**Strike-Out Tentative
Waste Discharge Requirements/Water
Reclamation Requirements
Order R4-2008-XXXX**

ORDER NO. R4-04-XXXX
WASTE DISCHARGE REQUIREMENTS and
WATER RECLAMATION REQUIREMENTS
FOR
MALIBU LUMBER LLC - CITY OF MALIBU'S
MALIBU LUMBER AT THE CITY OF MALIBU'S LEGACY PARK
(File No. 02-058)

November 24, 2008

~~Figure 2~~

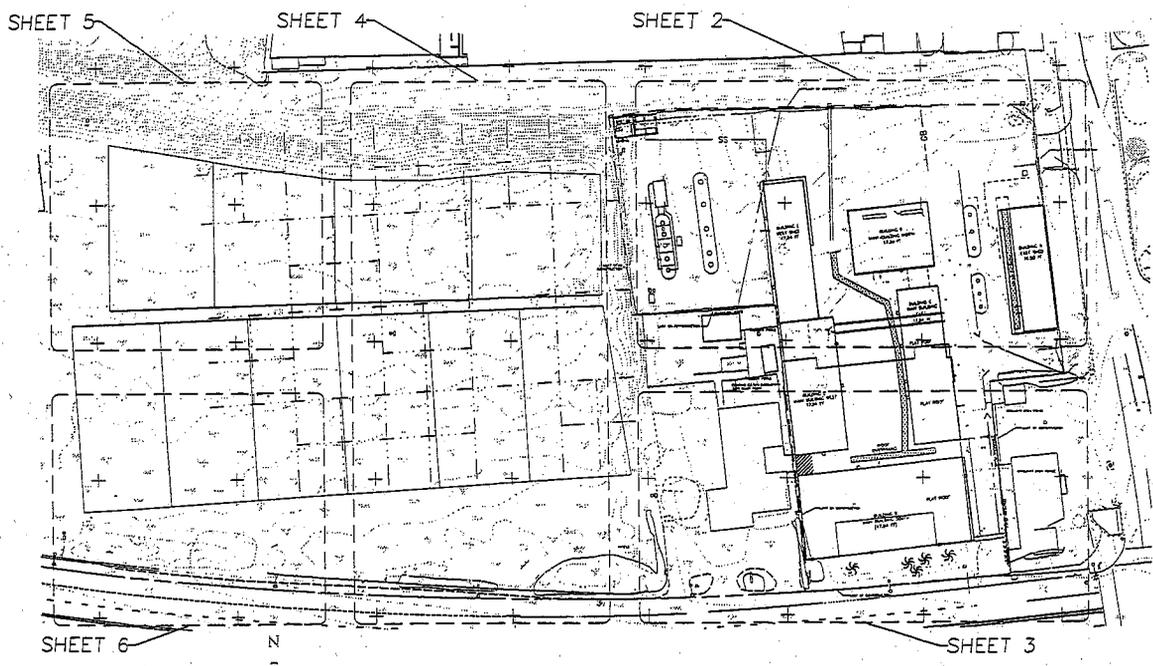
~~(Legacy Park map Final Malibu Engineering Design including modifications made for low flow to be provided by the Discharger)~~

FIGURE 1

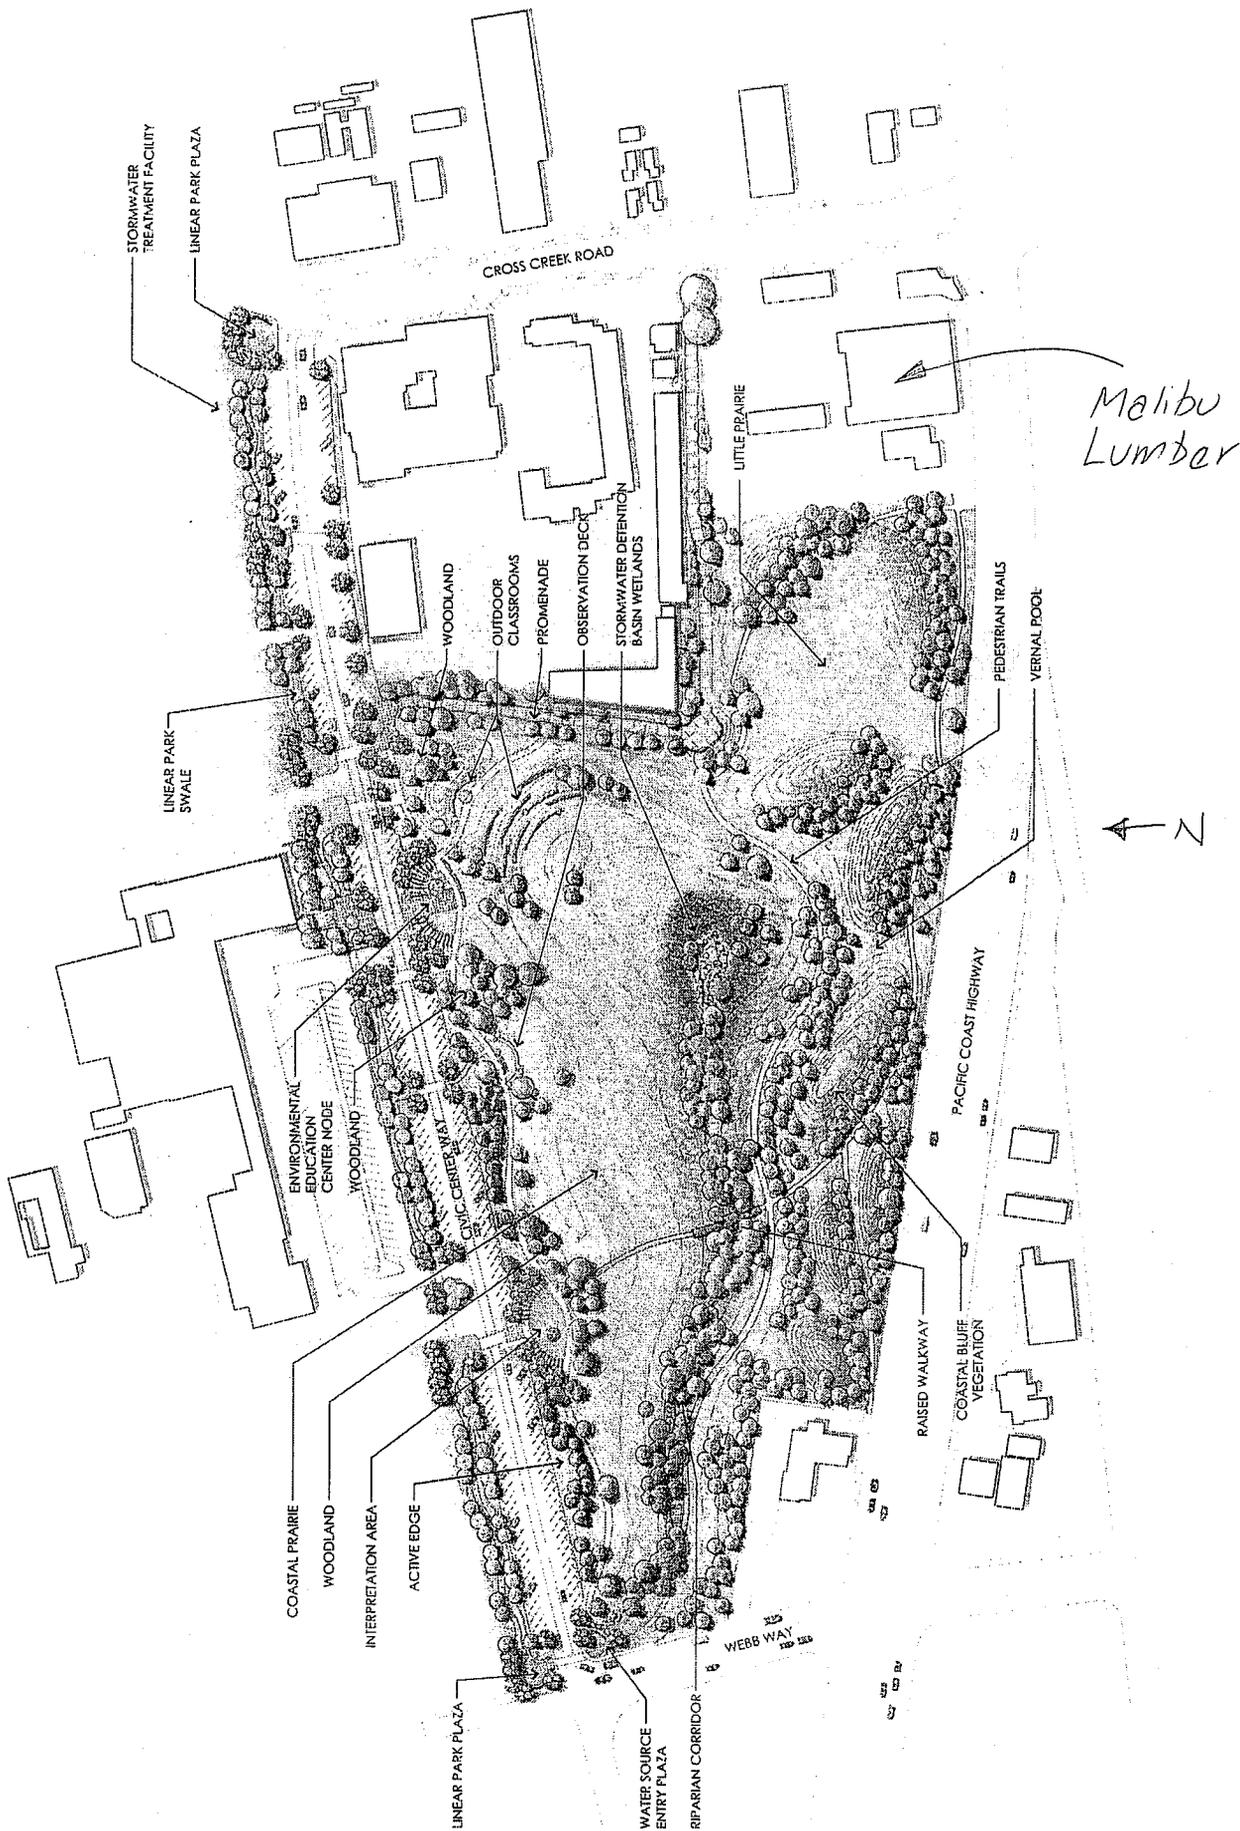
~~Figure 1~~

~~(Final Malibu Lumber map) map showing overlap with DEIR Construction plans for Legacy Park and cross sections showing the separation between the base of the Malibu Lumber leach field and the highest recorded water table to be provided by the Discharger)~~
